HISTORIC AND DESIGN REVIEW COMMISSION

June 19, 2019

HDRC CASE NO: 2019-259
ADDRESS: 119 BUFORD
LEGAL DESCRIPTION: NCB 1369 BLK 6 LOT S 81.3 FT OF 4
ZONING: R-4, H
CITY COUNCIL DIST.: 2
DISTRICT: Dignowity Hill Historic District
APPLICANT: Mark Granato/Granato Custom Homes
OWNER: Mark Granato/DAL HOLDINGS LLC
TYPE OF WORK: Construction of a 1 story, single family residential structure
APPLICATION RECEIVED: April 30, 2019
60-DAY REVIEW: June 29, 2019
CASE MANAGER: Edward Hall
REQUEST:

The applicant is requesting a Certificate of Appropriateness for approval to construct a one story, single family residential structure on the vacant lot at 119 Buford, located within the Dignowity Hill Historic District.

Site Plan

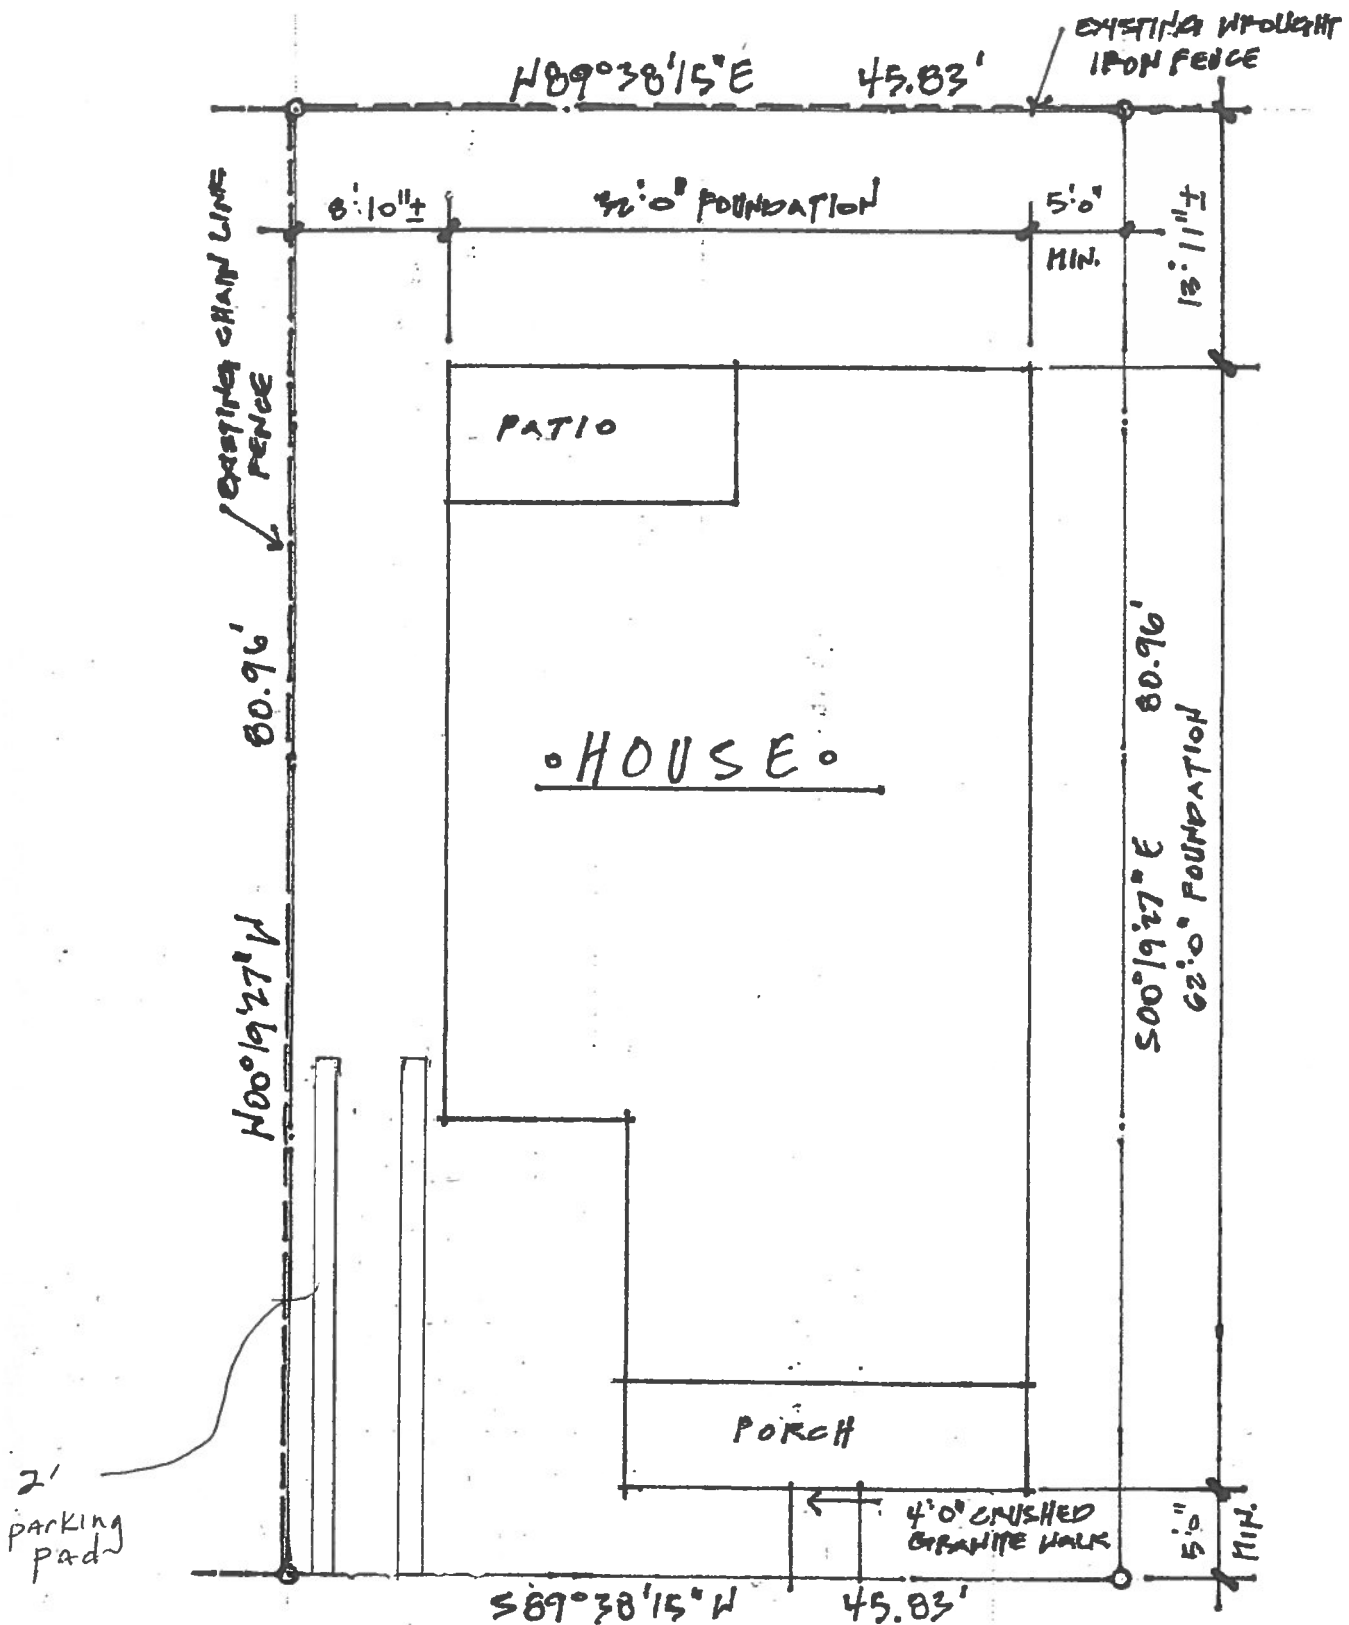
- vi. That a landscaping plan be submitted.
- c. **SETBACKS & ORIENTATION** – According to the Guidelines for New Construction, the front facades of new buildings are to align with front facades of adjacent buildings where a consistent setback has been established along the street frontage. Additionally, the orientation of new construction should be consistent with the historic example found on the block. Per the application documents, the applicant has proposed a setback of seven (7) feet front the front property line. Historic structures on this block feature setbacks that range in depth from approximately nine (9) to approximately fifteen (15) feet, when measured from the edge of the street paving. The applicant should propose a setback that is greater than the neighboring structures as well as those found on the north side of Buford Alley. To ensure that the proposed new construction is not built forward of the existing structures, staff finds that a site plan that includes the setbacks of adjacent structures should be submitted.

- l. **DRIVEWAY** – The applicant has proposed a ribbon strip driveway to be located on the west side of the proposed new construction. Staff finds the proposed profile and location of the driveway to be appropriate and consistent with the Guidelines. Staff finds that the driveway should not feature more than ten (10) feet in width.

- m. **SIDEWALK** – The applicant has proposed a front sidewalk consisting of decomposed granite. The Guidelines for Site Elements 5.A.iii. notes that the alignment, configuration and width of sidewalks should be followed when installing new sidewalks and walkways within historic districts. The historic pattern in the Dignowity Hill Historic District is for a concrete front sidewalk feature approximately three (3) feet in width. Staff finds that the applicant should adhere to the historic pattern found within the district.

- i. That the applicant confirm that the proposed setback is greater than those of the neighboring historic structures.
- ii. That the applicant incorporate additional fenestration on the east façade.

- v. That all mechanical equipment be screened from view from the public right of way.
- vi. That the proposed ribbon strip driveway not exceed ten (10) feet in width.

- vii. That the proposed front sidewalk be concrete and feature a width of approximately three feet to match those found historically on the block.
- viii. That the applicant submit a detailed landscaping plan to staff for review and approval.

Right Side Elevation

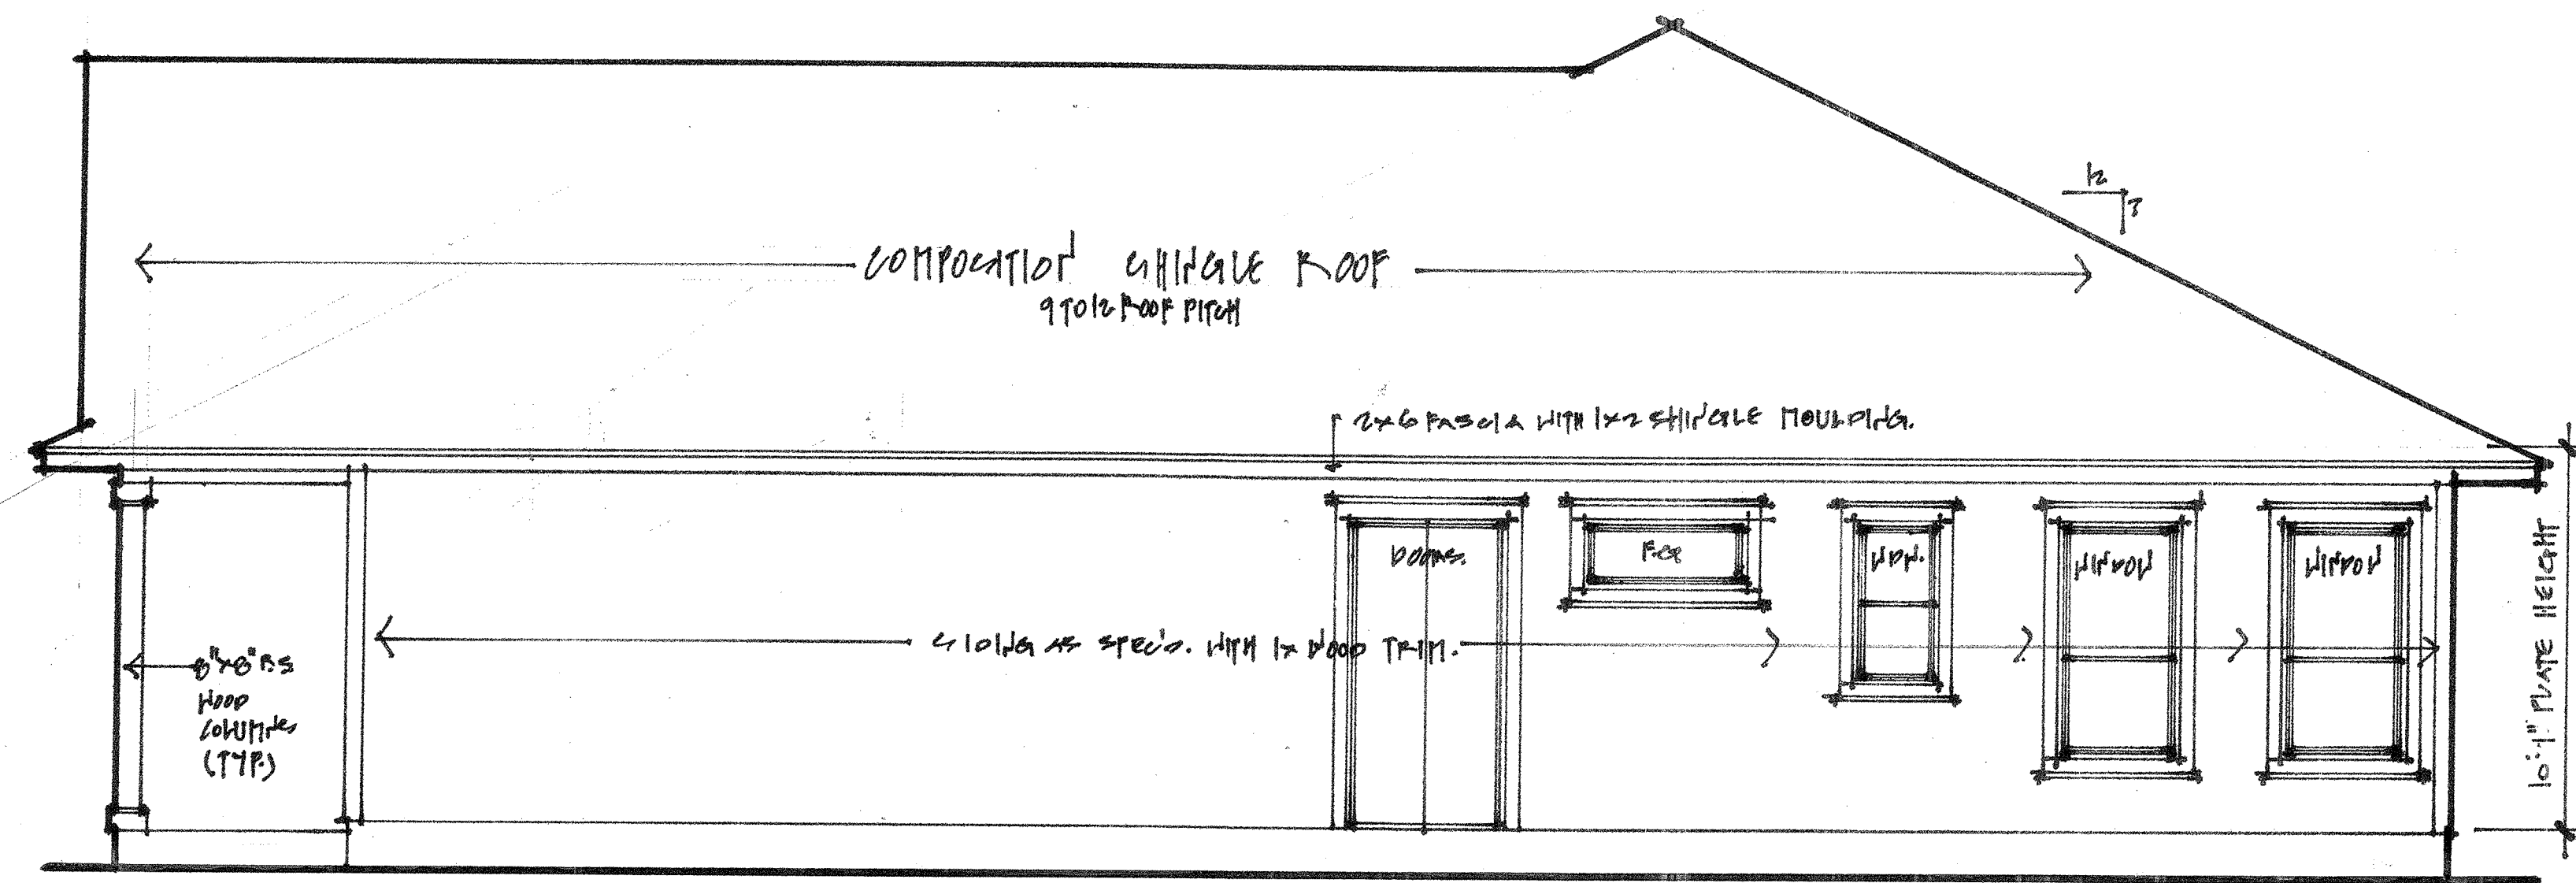
- h. **ARCHITECTURAL DETAILS** – The applicant has proposed an overall form and massing that are comparable to that found on Buford Alley and predominantly throughout the Dignowity Hill Historic District. Staff finds that additional fenestration along the east facade, particularly in the living room and on the west façade in the dining area should be added to separate wall planes that are currently blank.
